UNITED STATES ENVIRONMENTAL PROTECTION AGENCY
REGION 10
1200 Sixth Avenue
Seattle, WA 98101

The U.S. Environmental Protection Agency (EPA) has reviewed the draft Environmental Impact Statement (EIS) for the **Klamath Hydroelectric Project** (CEQ No. 20060395) (Project) located principally on the Klamath River in Klamath County, Oregon and Siskiyou County, California, between Klamath Falls, Oregon and Yreka, California. Our review has been conducted in accordance with our responsibilities under the National Environmental Policy Act (NEPA) and Section 309 of the Clean Air Act.

Klamath Hydroelectric Project Draft Environmental Impact Statement EPA Detailed Comments

Figure 1 : Plot of Temperature Shift below Iron Gate Dam based on Pacificorp Model (draft EIS, Figure 3-37)

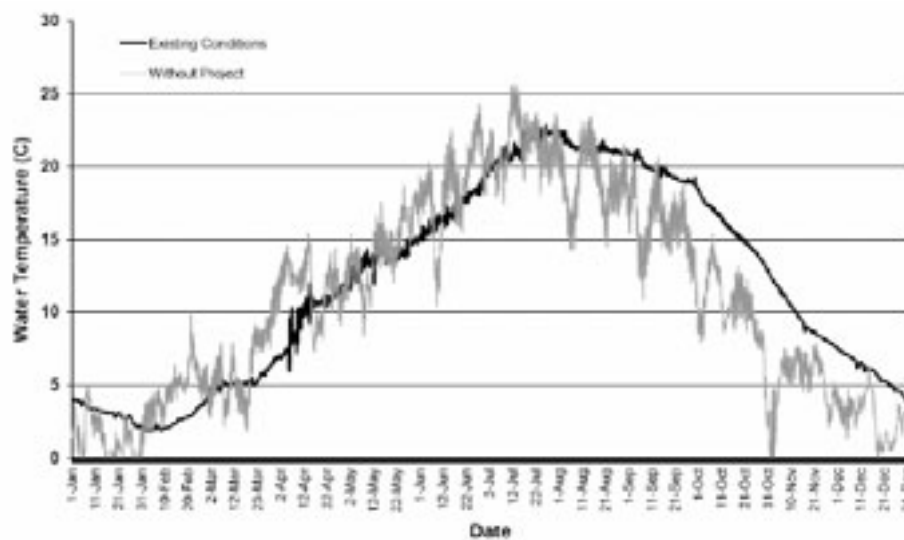
The draft EIS indicates that, by causing a shift in the seasonal thermal regime, Copco No.1 and Iron Gate Dams directly impact the temperatures of the downstream Klamath River (see Figure 1 below). Temperature increases in the Fall are of particular concern because they would exceed the 2.8° C (5° F) allowable increase in California water quality criteria (Table 3-24). The draft EIS does not clearly explain how these increases are consistent with the California narrative criteria that state “At no time shall temperature be increased by more than 5° F above natural receiving water temperature.” While the full impact of the dams on the applicable California water quality standards has not yet been fully analyzed in a TMDL, information presented by Bartholow, et al, 2003 (see Figures 2, 3, 4 and 5 below) indicates that significant reductions in Fall outflow temperatures would be needed to achieve California’s applicable water quality criteria for temperature (no greater than 2.8° C increase).

Although the draft EIS does not analyze whether the dams can be modified to achieve California temperature standard, it does contain some analysis of the potential improvements achievable using a selective withdrawal system. From this analysis, the draft EIS concludes: “Sustained temperature relief of more than 2 weeks to the Klamath River via releases from Iron Gate Dam is not feasible. However, the cold water pool in Iron Gate has the potential to cool downstream temperatures on a short-term basis, and could be considered for extreme circumstances should environmental conditions trigger such a need (e.g., when large numbers of juvenile salmonids are present in the river under extreme temperature stress) (page 3-138).” Given that the Fall temperature impact of the Copco No.1 and Iron Gate Dams exceeds the 2.8° C water quality criteria for a period of months, it is not clear whether any of the alternatives would achieve water quality standards.

Figure 6: Plots from Tetra Tech Draft Modeling Report (unpublished) showing calibration runs for various water quality parameters compared to their current conditions monitoring results.

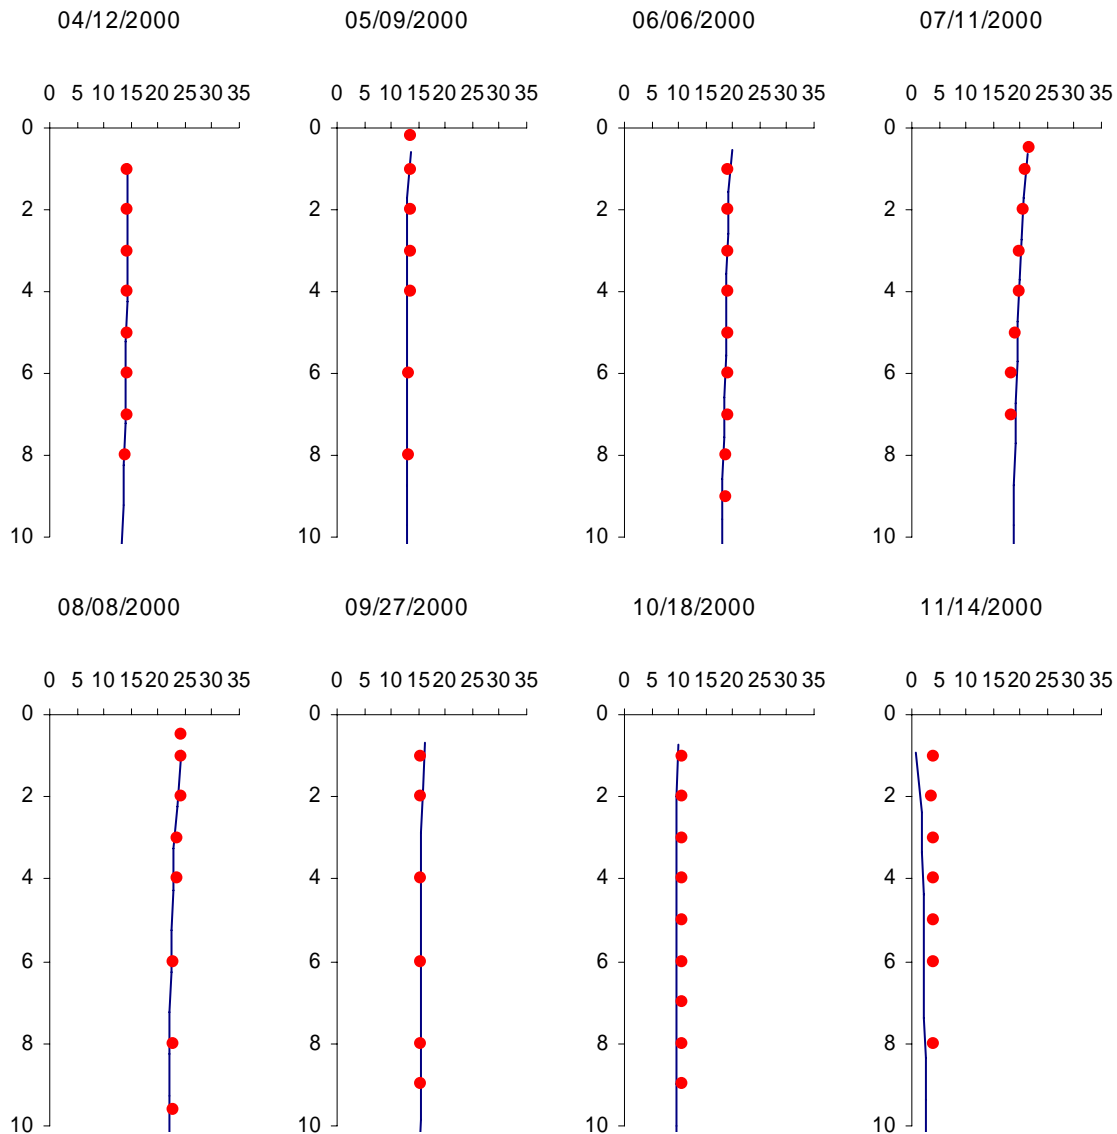
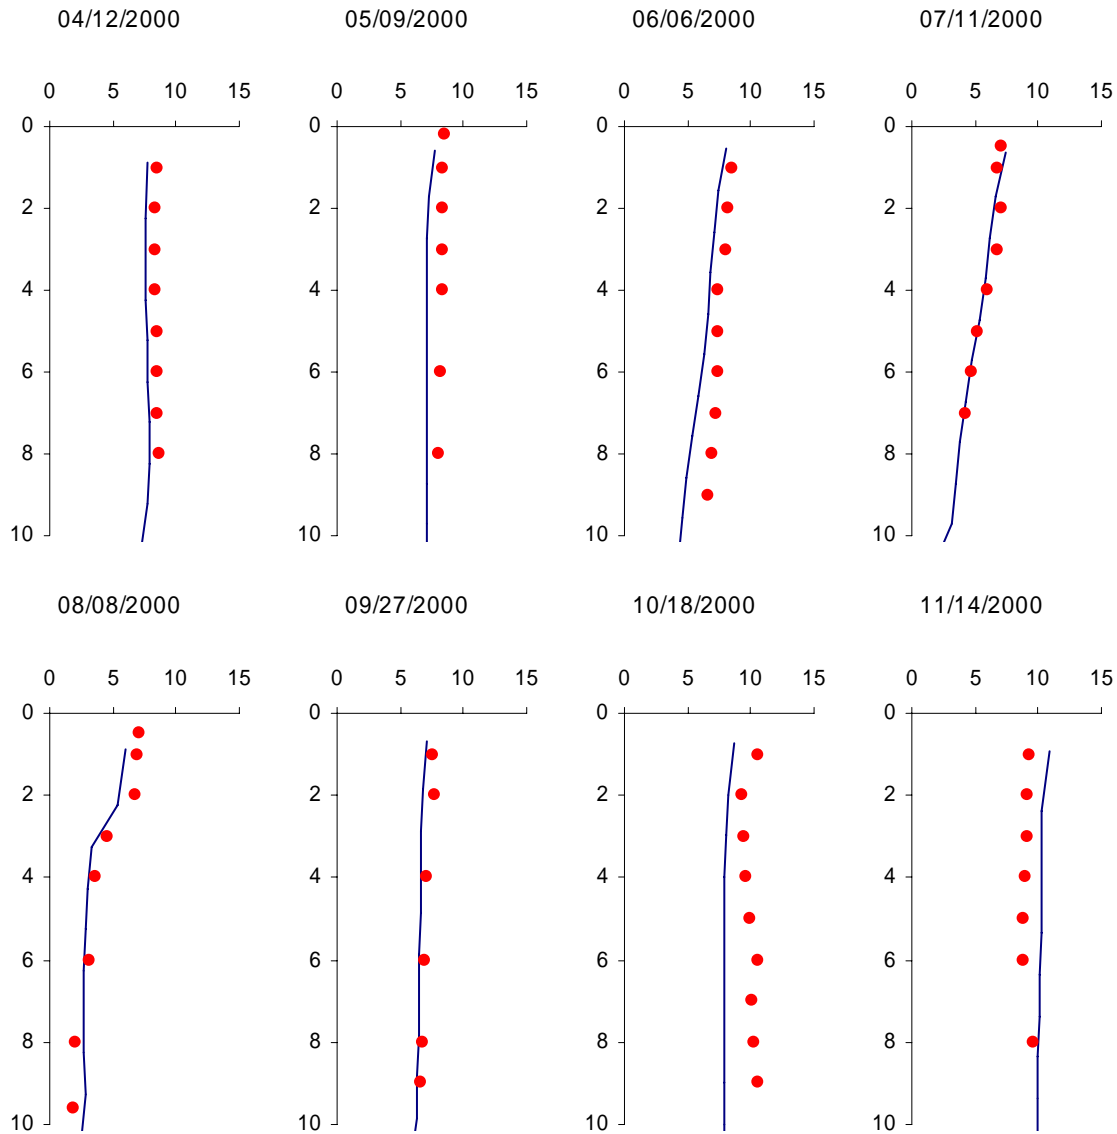
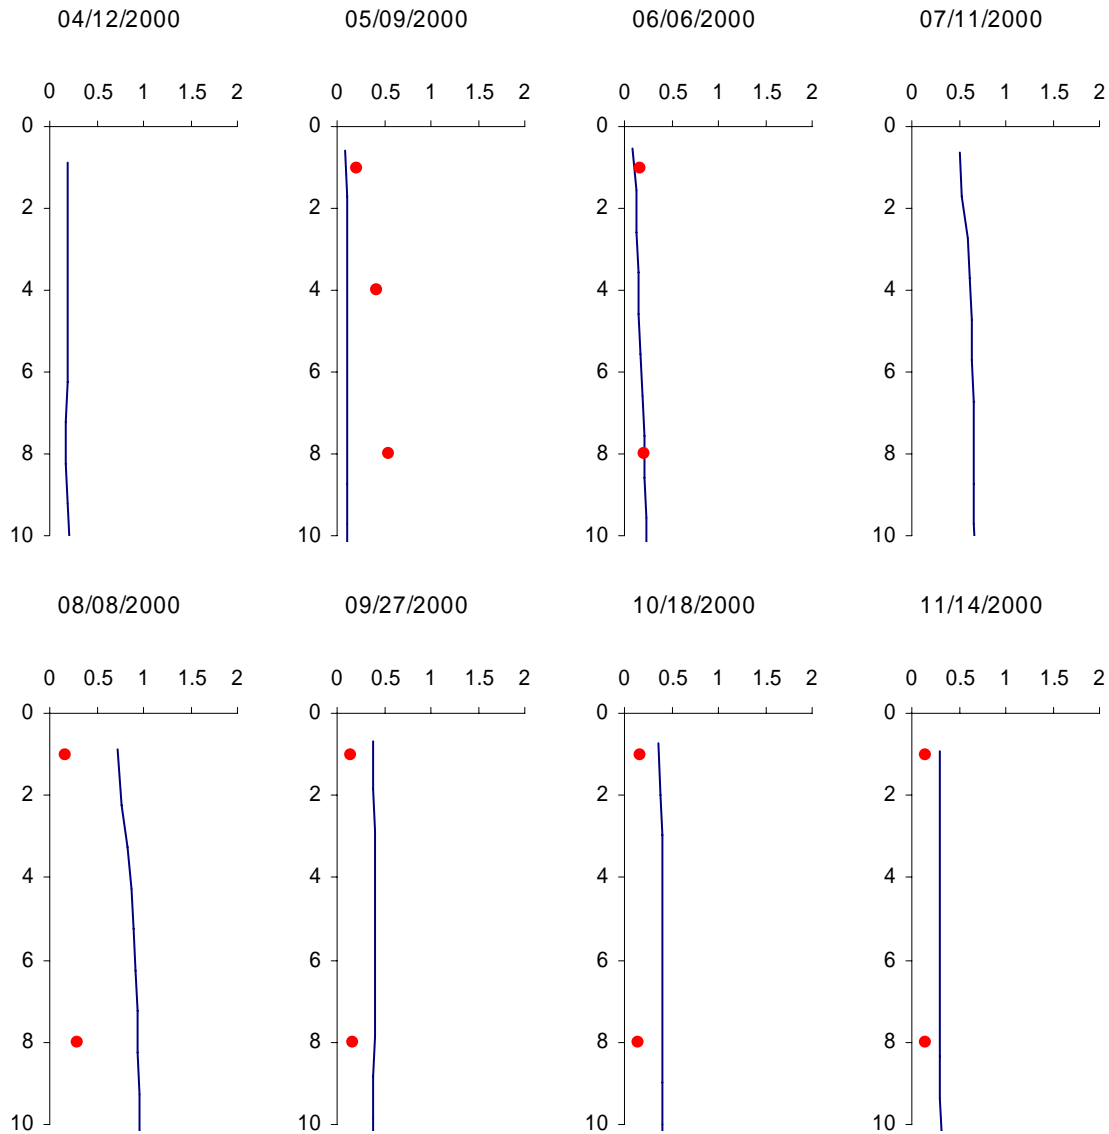
The draft EIS presents an analysis of temperature and dissolved oxygen criteria exceedences below Iron Gate Dam; temperature above and below J.C. Boyle; and, temperature within Copco No.1 and Iron Gate reservoirs, but similar analyses are not presented for all Project structures or for waters between the structures. Similarly, the draft EIS does not include a complete analysis of the Project’s compliance with pH and ammonia water quality criteria. Data developed by Oregon and California in the course of their TMDL analysis indicates that there would be exceedences of temperature, dissolved oxygen, pH, and ammonia water quality criteria

throughout the Project area at various times of the year (see attached model calibration results prepared by Tetra Tech (Figures 6, 7 and 8 below)).

We recommend that the final EIS include a more thorough analysis of all relevant water quality parameters for each Project structure and the waters between the structures and discuss the impacts the Project has on applicable state and tribal water quality standards. Such an evaluation would provide important information regarding whether a proposed alternative is consistent with all applicable state and tribal water quality standards.

Figure 9: Estimated Effects of Flow Fluctuation on Temperature Below J.C. Boyle Powerhouse Discharge.

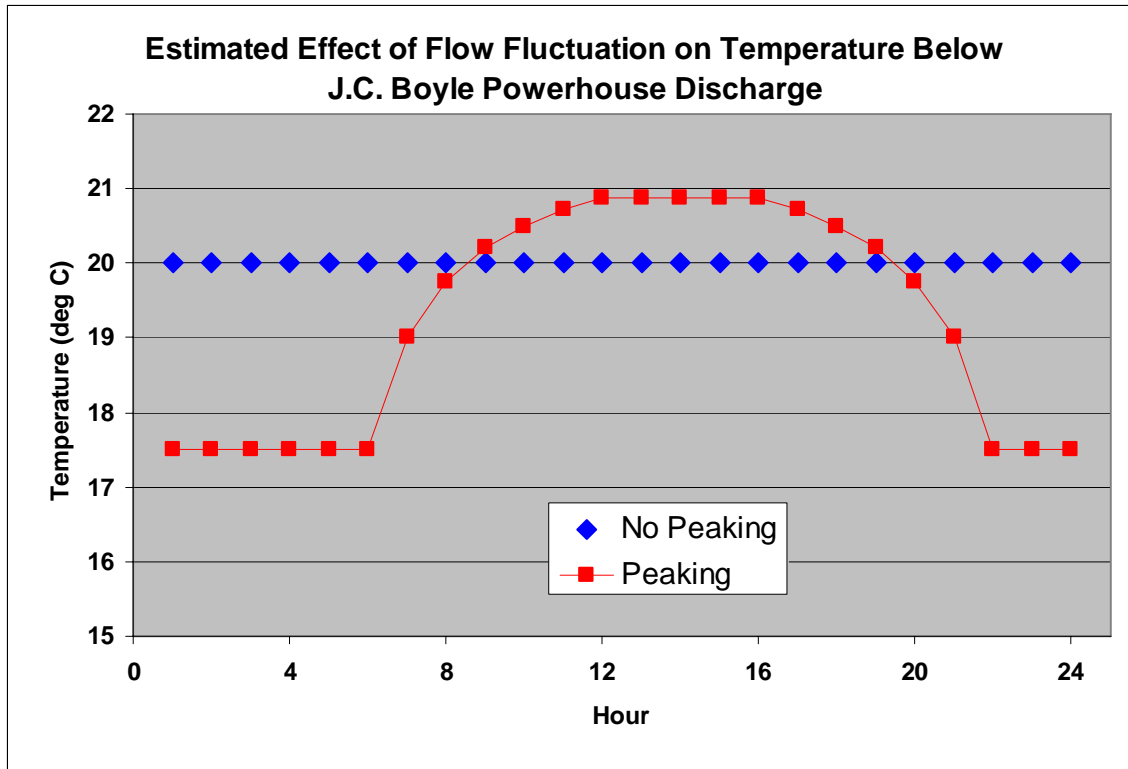
The draft EIS does not include an analysis of the impacts of peaking operations at the J.C. Boyle powerhouse on exceedences of the Oregon water quality temperature standard downstream from the dam. While the document discusses how the powerhouse increases the diel range of temperatures observed in the bypass reach, Oregon water quality standards include requirements to restrict human-caused increases to maximum temperatures. EPA performed a screening calculation on information in the draft EIS based on river flows and temperatures. Our calculation indicates that peaking may increase the maximum daily temperature downstream of the powerhouse compared to temperatures under steady powerhouse flows (see Figure 9 below).

EPA recommends that the final EIS include a more thorough evaluation of the effects of peaking at the J.C. Boyle Dam on temperature and the implications for achieving Oregon water quality standards.
